## **Wilmington International Airport (ILM) Curbside Improvements Phase 2**

Addendum No. 3 | Issue Date: 05/05/2025

**PROJECT TITLE:**  
ILM AIRPORT ROADWAY AND  
PARKING IMPROVEMENTS -  
PHASE II

**SHEET TITLE:**  
PERFORATED METAL  
PANEL DETAILS

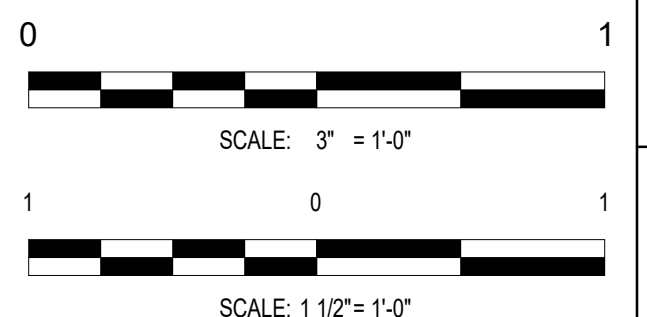
A504 - PERFORATED METAL PANEL DETAILS  
**ADDED** SHEET AND DETAILS FOR PERFORATED METAL PANEL

## SCUPPER DETAILS

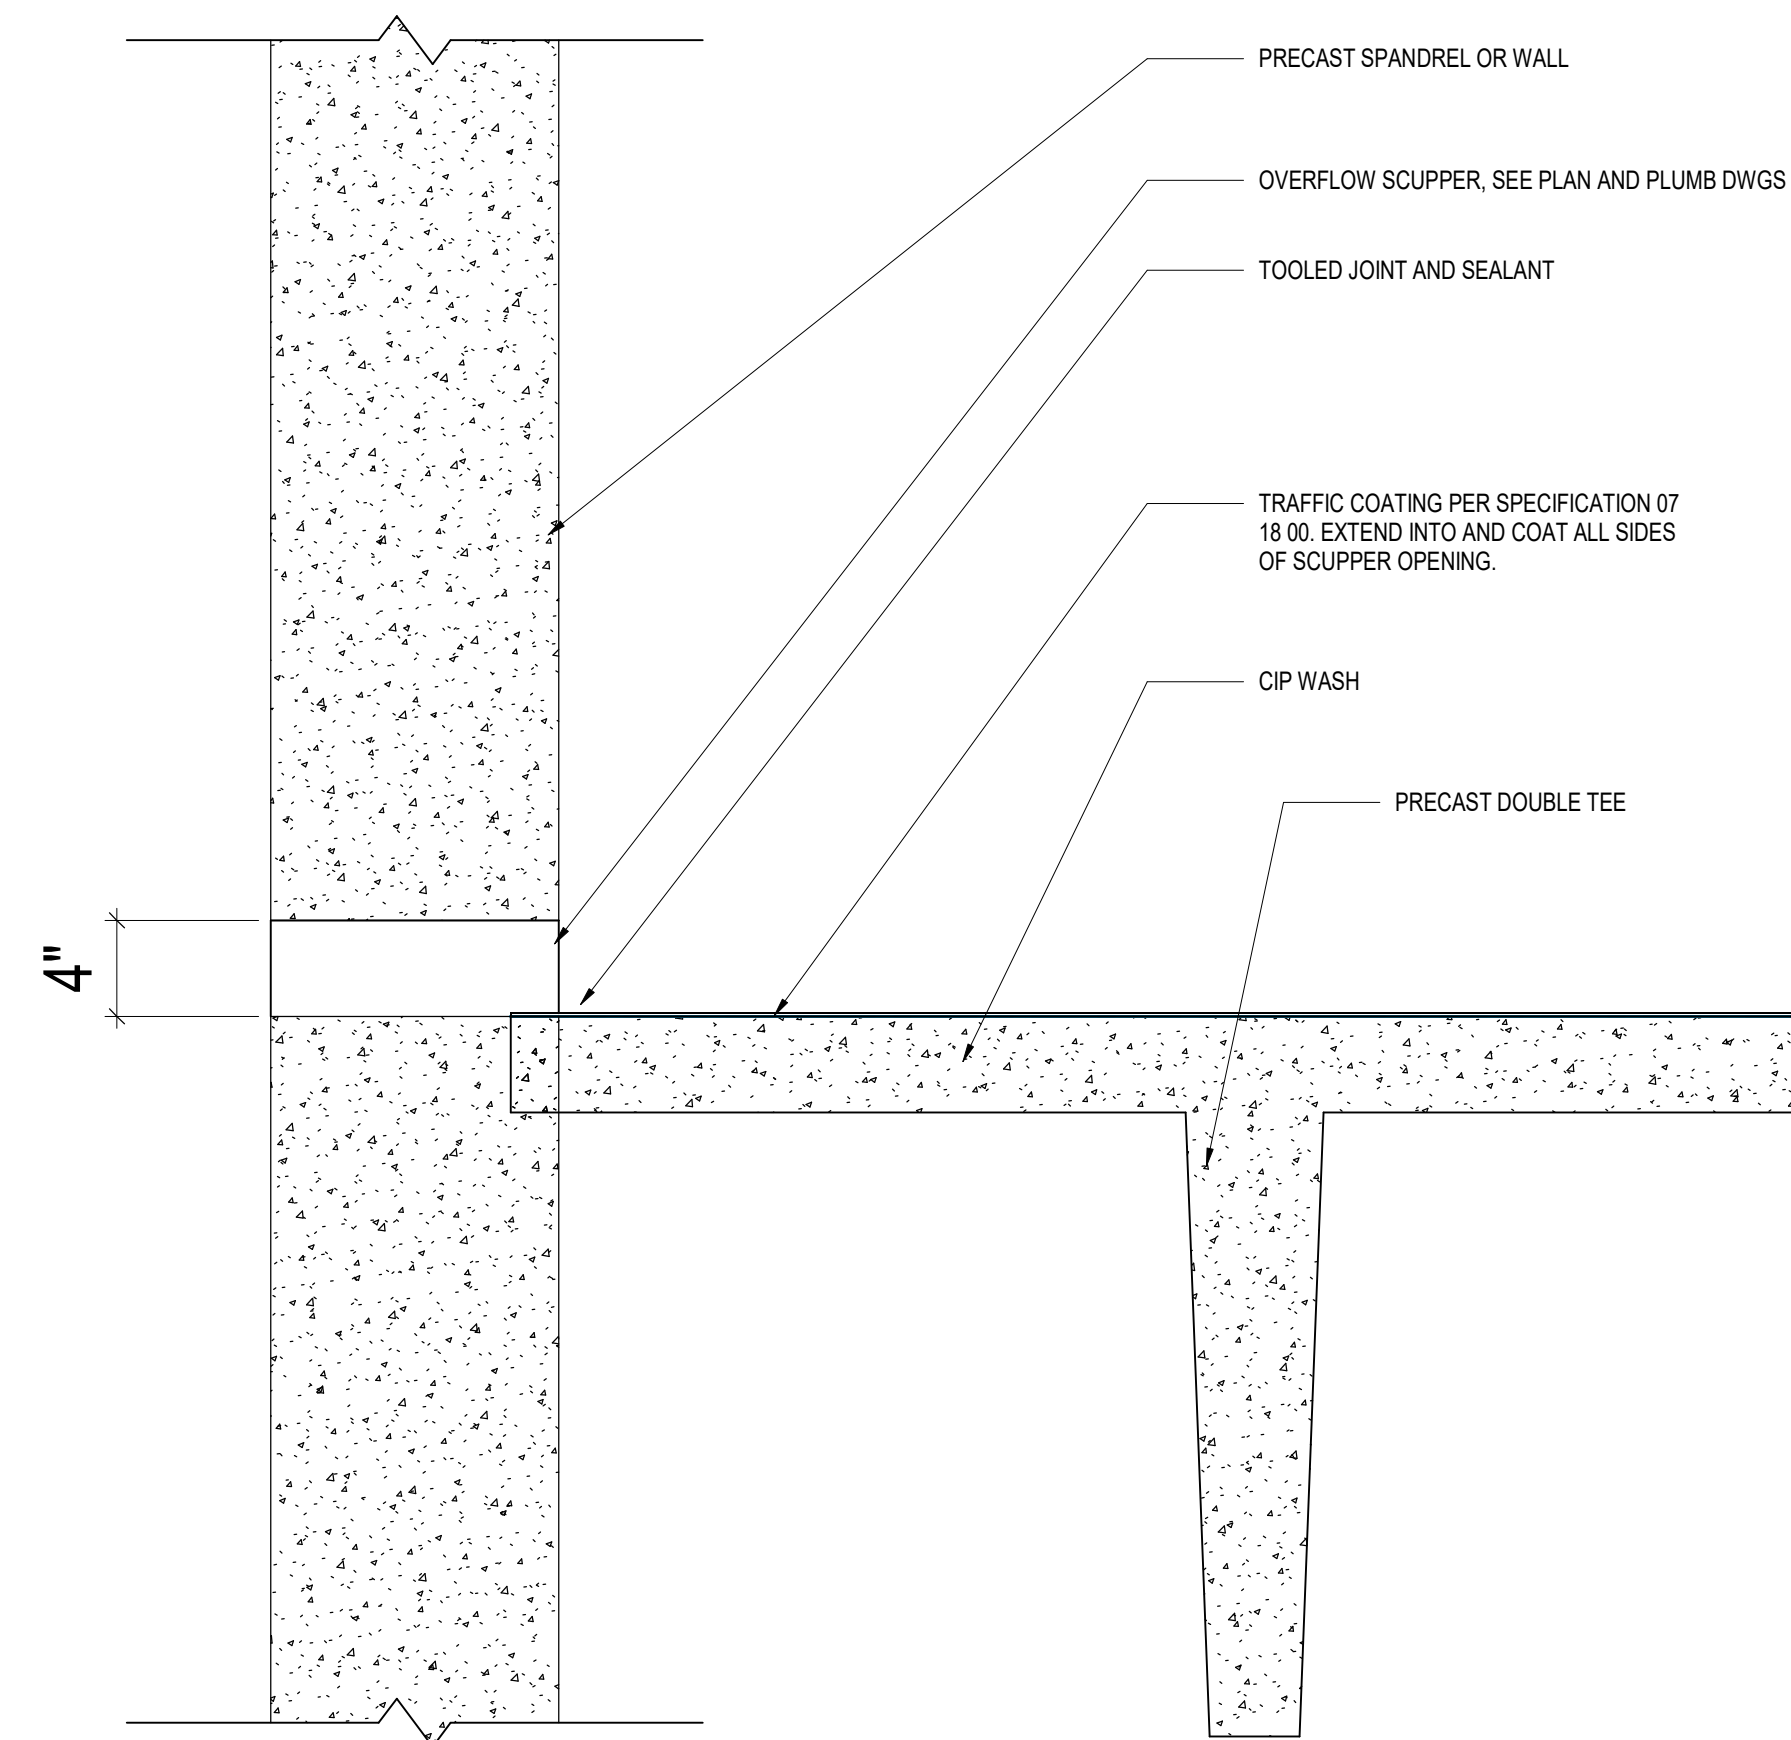
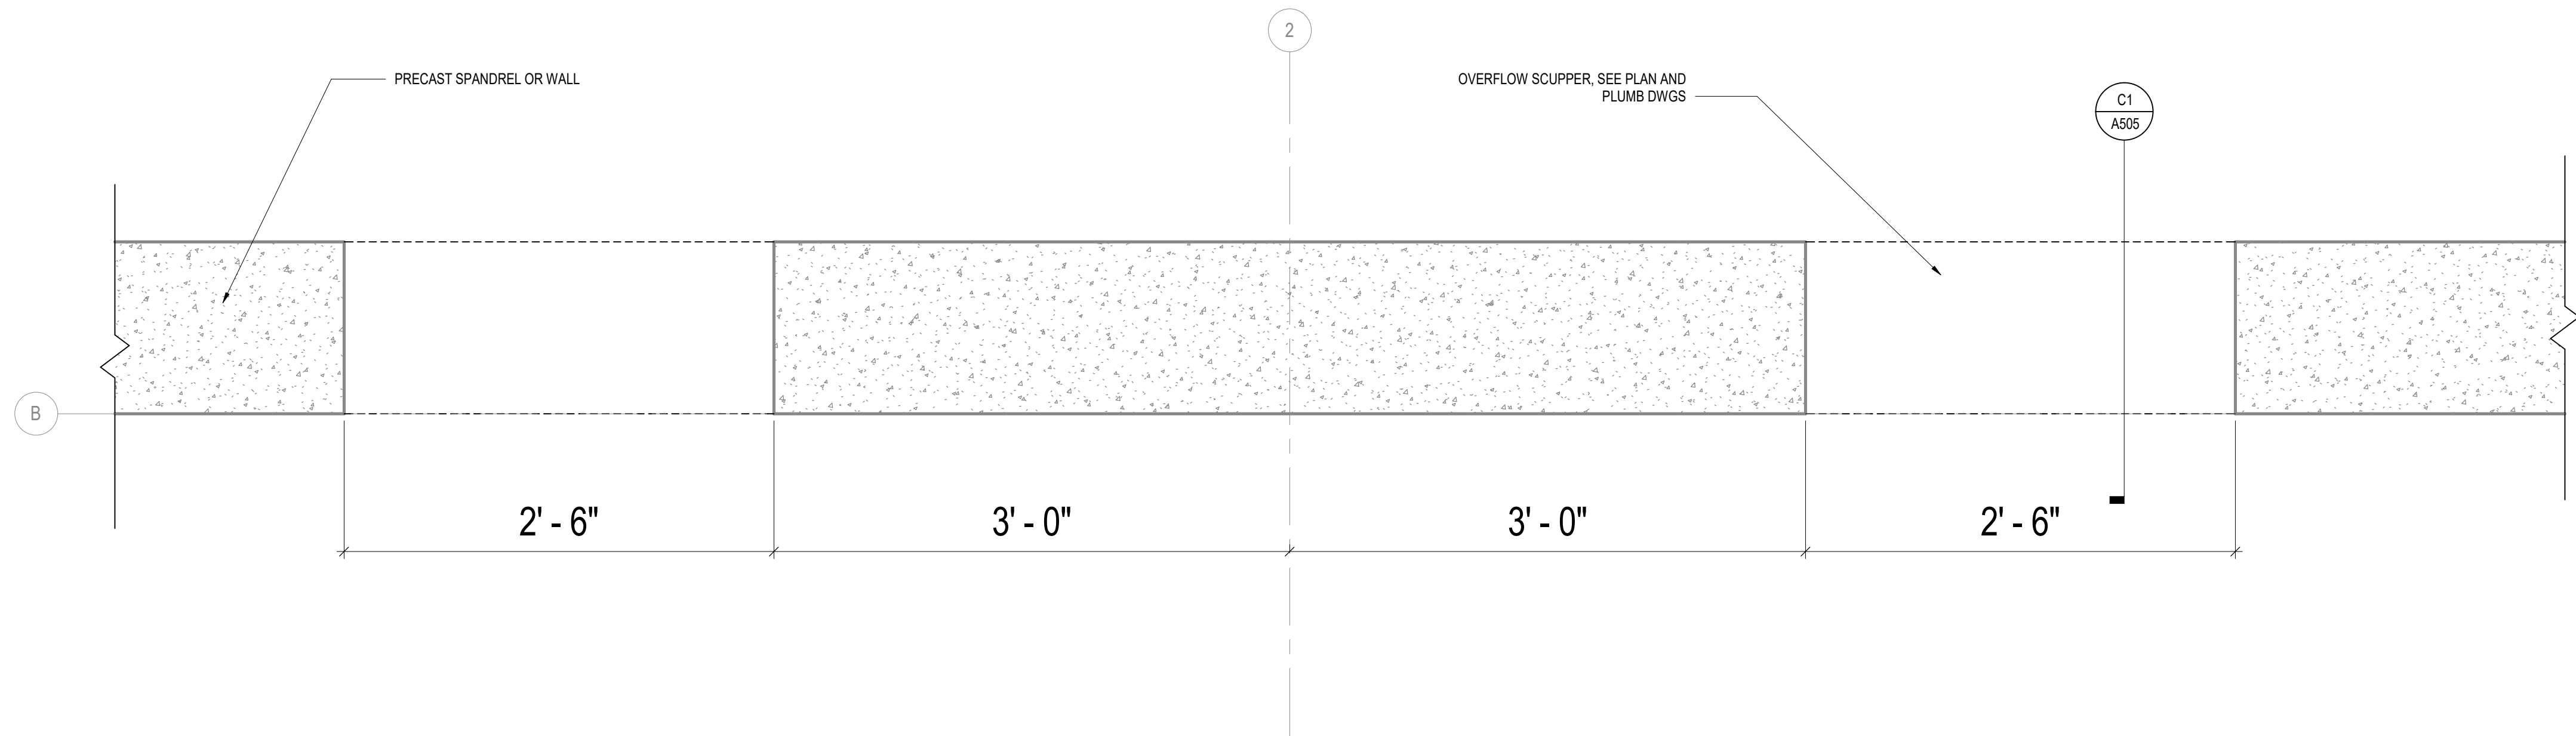
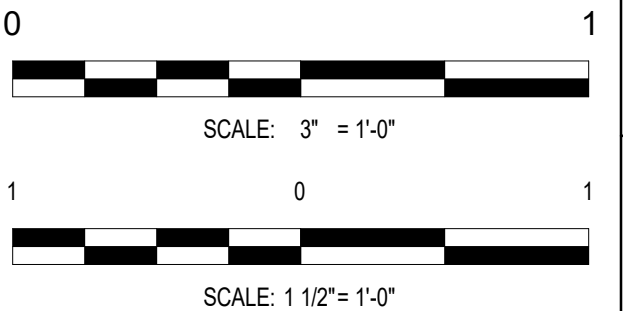
A505 - SCUPPER DETAILS  
**ADDED** SHEET AND DETAILS FOR SCUPPER DETAILS

SHEET TITLE:  
FIRST FLOOR  
ELECTRICAL LIGHTING  
PLAN

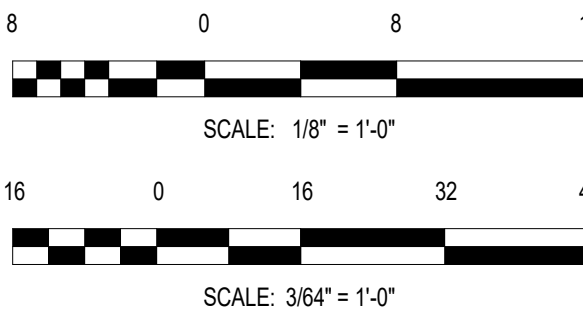
EL111  
**ADD** SAIL LIGHTING

**OVERALL TICKETING  
LEVEL FURNITURE  
PLAN**

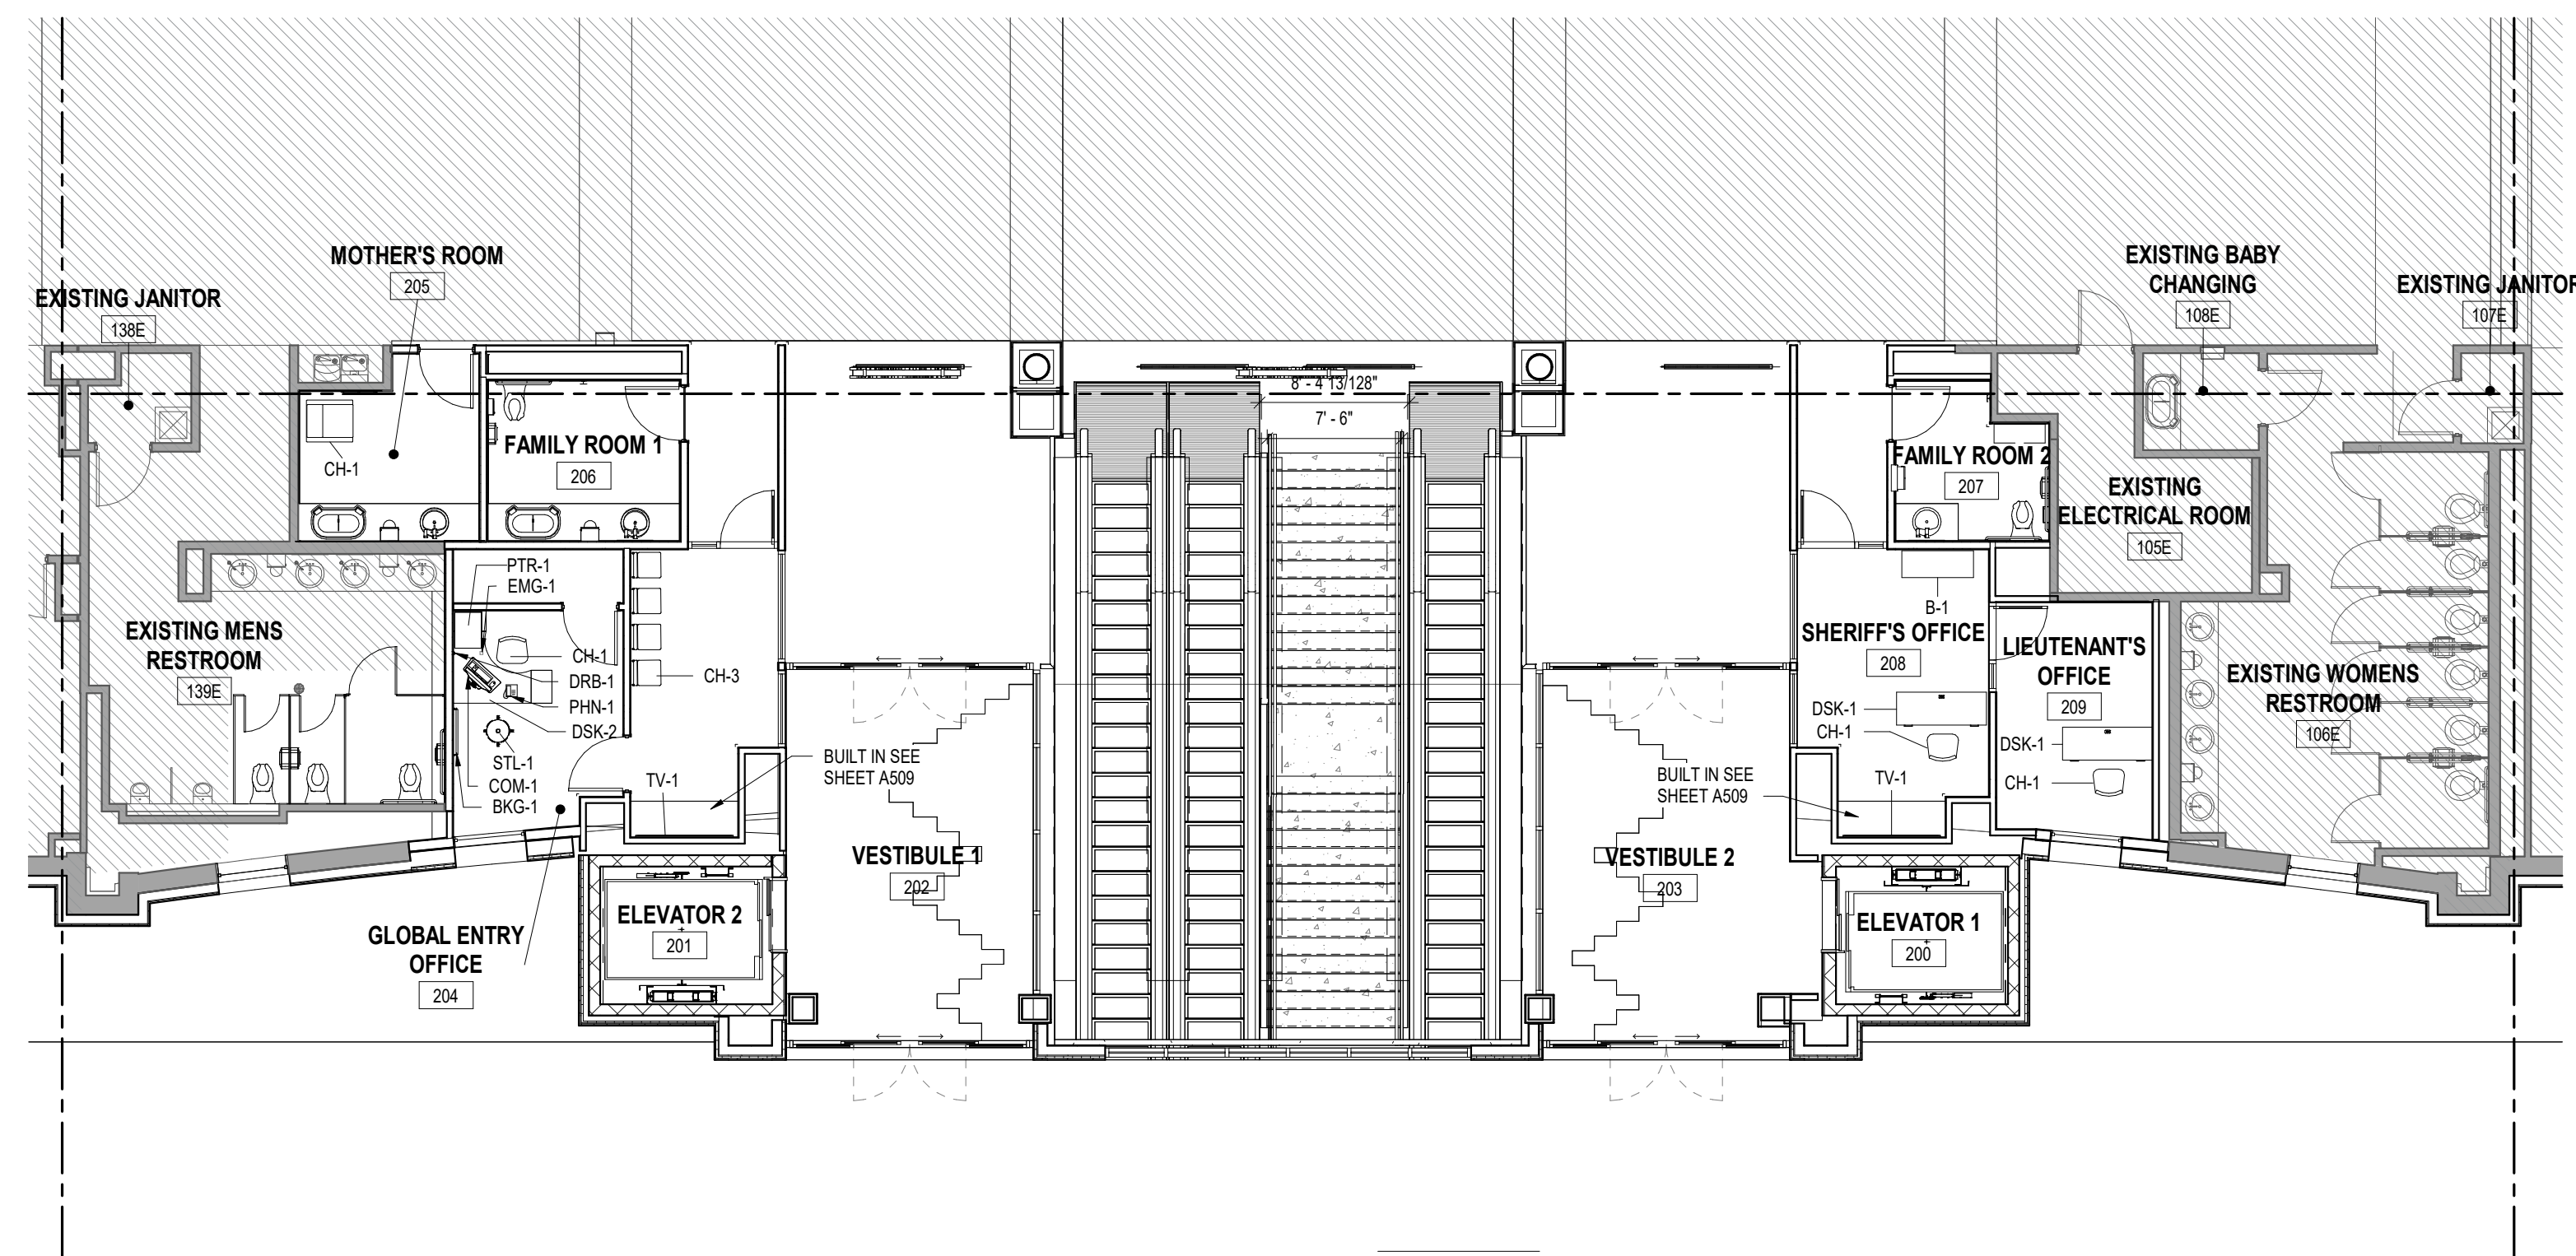
A812 - OVERALL TICKETING LEVEL FURNITURE PLAN  
DESK CLARIFICATION
